**CERTIFICATE OF APPROPRIATENESS**

**Property:** 802 Arlington Street, Tracts 13A & 14A, Block 250, Houston Heights Subdivision. The property includes a historic 2,210 square foot 1½-story wood frame single family residence and attached garage situated on an 8,200 square foot (100' x 82') corner lot.

**Proposal:** Alteration – Revision. Alter the non-original front dormer window to meet egress requirements. The existing dormer features a non-operable divided arch window. The dormer will be extended forward and a single casement window will be installed.

**SOUTH SIDE ELEVATION**  
**EXISTING**

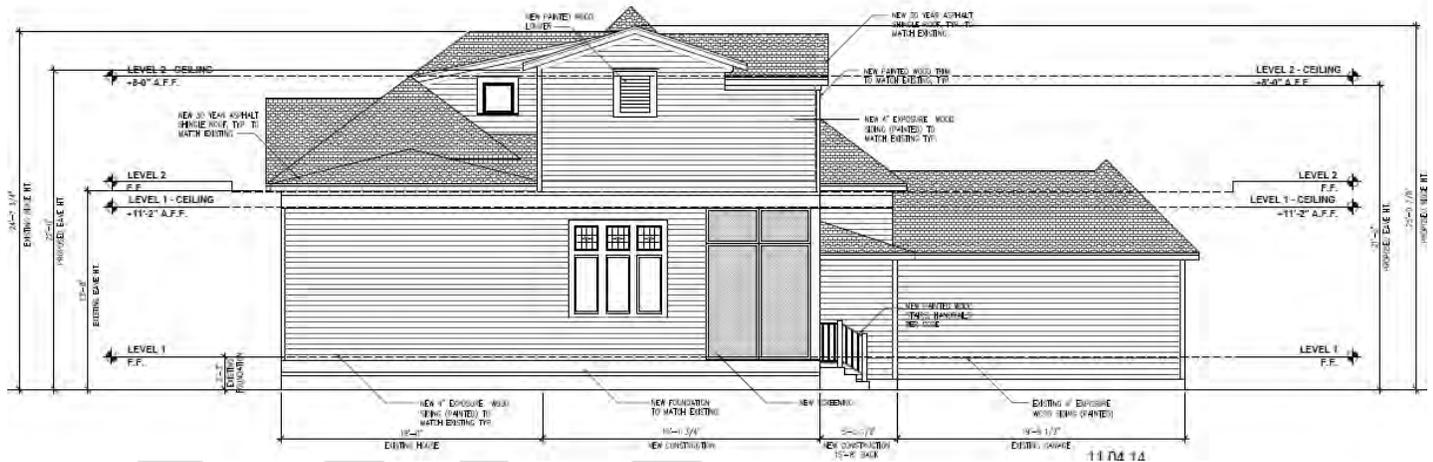
**Side Elevation:** In the proposal, the side profile of the dormer will extend 3'-3" forward (to the west). See drawings for more detail
